Access Compliance Report

Public Rights-of-Way

| Intersection ID: 50584 | Main Street: GREAT_LAUREL_RD | Cross Street: GRAND_FIR_RD | Location: SW |
| ADA ID: A0EBD53314A4 | Ramp Type: Perp | Initial Pass/Fail: Fail | Overall Compliance: No |

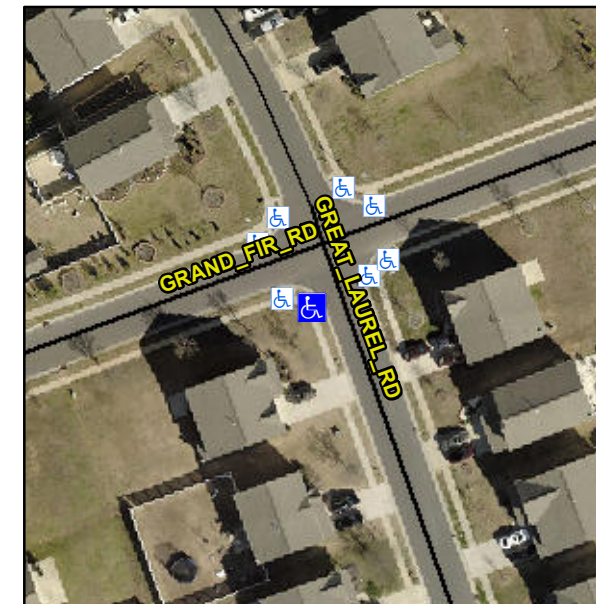
Not Found, R304.5.1, R304.5.3

| Compliance | Description | Data | Compliance | Description | Data |
|------------|-----------------------|------|------------|-----------------------------|------|
| No | Ramp Width (in) | 42.5 | No | Ramp XSlope (%) | 3.8 |

Remove & Replace Entire Ramp.
